STATE OF MAINE DEPARTMENT OF MARINE RESOURCES 21 STATE HOUSE STATION AUGUSTA, MAINE 04333-0021

November 12, 2024

Subject: Maine DMR comments on the Proposed Study Plan for the Brunswick Project (P-2284)

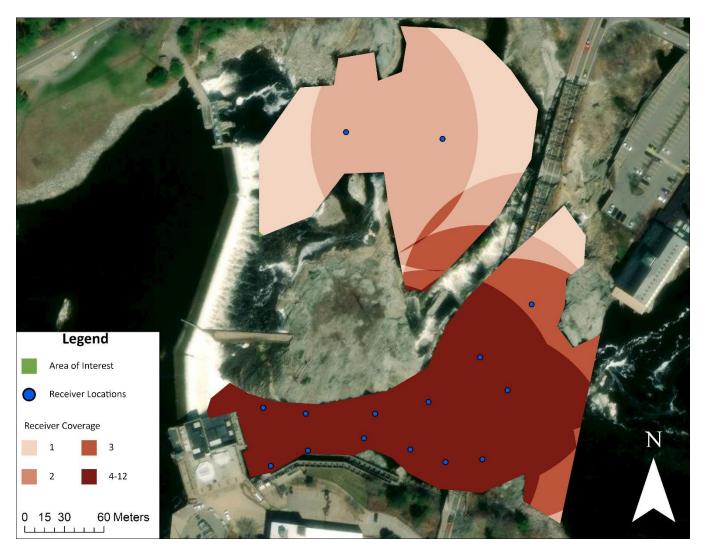
PDF Page 50: "Due to the relatively shallow water depths and high turbulence during spill conditions, BWPH does not intend to install acoustic receivers in the ledge areas located immediately downstream of the spillway." MDMR Comment: Due to the ability of sea lamprey and other species to climb wetted ledge structures, MDMR recommends that the study area includes the area below the spillway and tainter gate structures. It would be sufficient to install two receivers in this location to monitor presence/absence, and thus the ability for fish (particularly lamprey) to ascend the falls and move toward the spillway. We do not believe that this request will add substantially to the study as it will likely require less than two days to deploy and retrieve the receivers and will not require significant additional time to analyze the data from these two receivers. The study area should also include immediately below the falls to obtain information on fish falsely attracted to that area. The feasibility of installing acoustic receivers in these areas should be assessed prior to implementation of the study.

If installation is infeasible, the area should at least be monitored regularly with mobile tracking equipment when tagged fish (particularly sea lamprey) are known to be in the area.
